Report
on
Design and Stress Evaluation
of
Failed Main Steam Safety Valve Nozzle

H. B. Robinson No. 2
Carolina Power and Light Co.

Report No. DC-67

May 23, 1970

ANALYTICAL MODEL
OF SAFETY VALVE NOZZLE

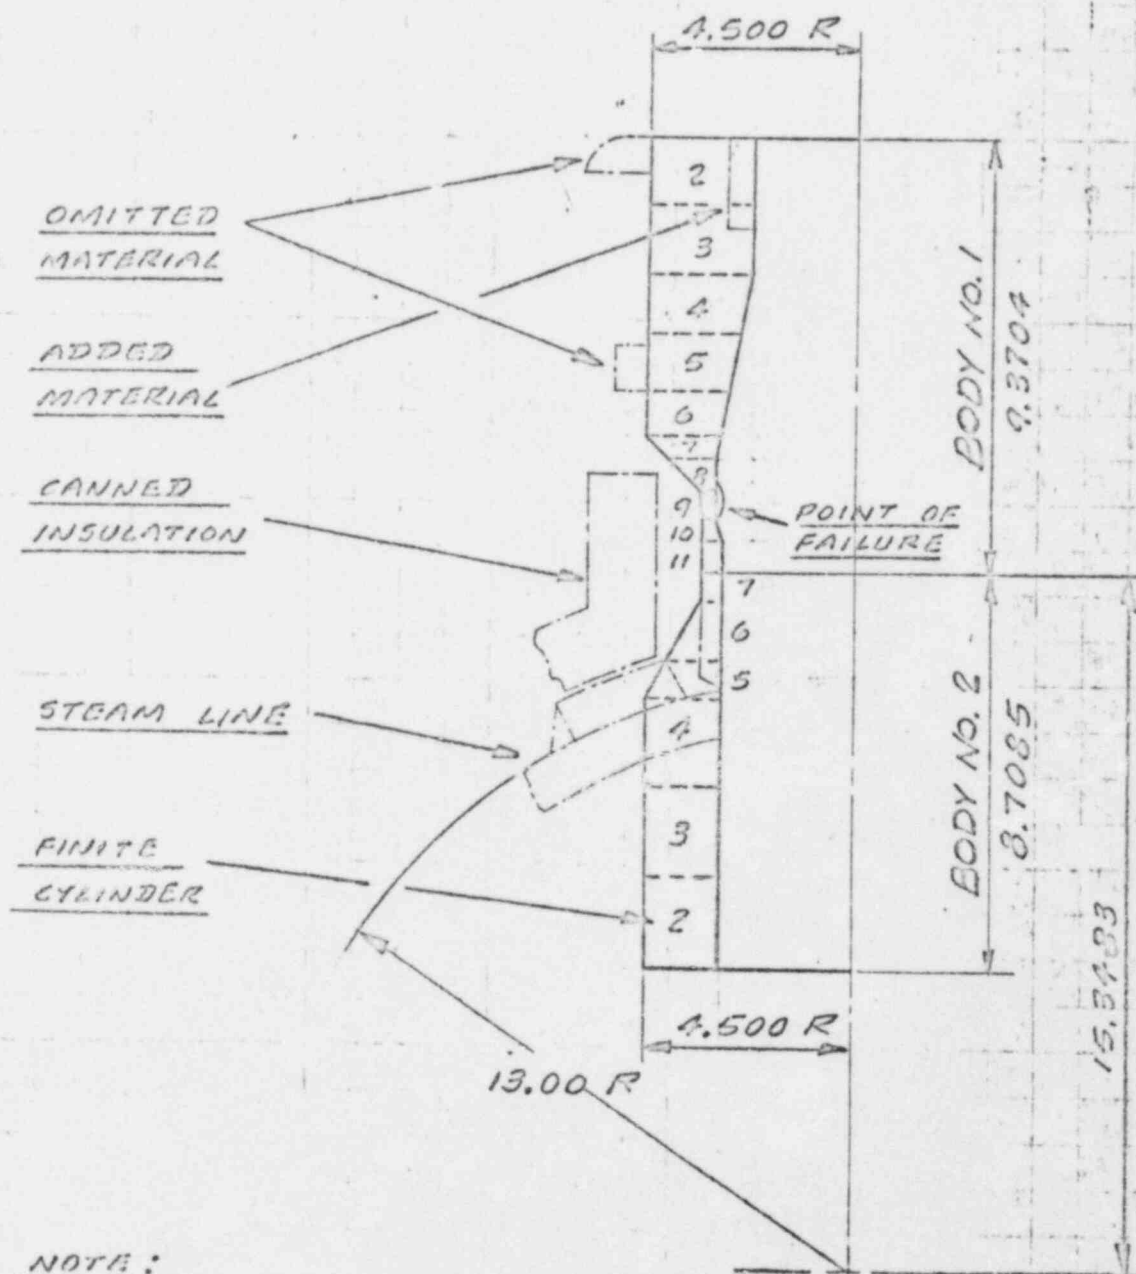
Because of a characteristic of the computer program, the nozzle is divided into two bodies as shown on the preceding page. The upper part of the nozzle and the point of failure are included in Body 1, which is subdivided into ten (10) short cylinders. The steam line, the reinforcing pad, the fillet welds and a short length of the nozzle are modeled as Body 2, which is subdivided into six (6) short cylinders. In order to seal internal pressure, a very thin "infinite" cylinder is located at each end of the analytical model.

To avoid complications, the upper part of Body 1 is modeled without steps. This simplification is justified by the practical observation that the flanges and the counterbore do not affect the failed Schedule 40 nozzle neck significantly.

The complex transition from nozzle to steam line is modeled very simply as a reasonably thick cylinder on the same axis as the nozzle. This simplification is justified by noting that the upper fillet weld is approximately a "long cylinder length" from the point of failure. In other words, neither the steam line nor the imaginary short cylinders interact significantly with the failed Schedule 40 nozzle neck.
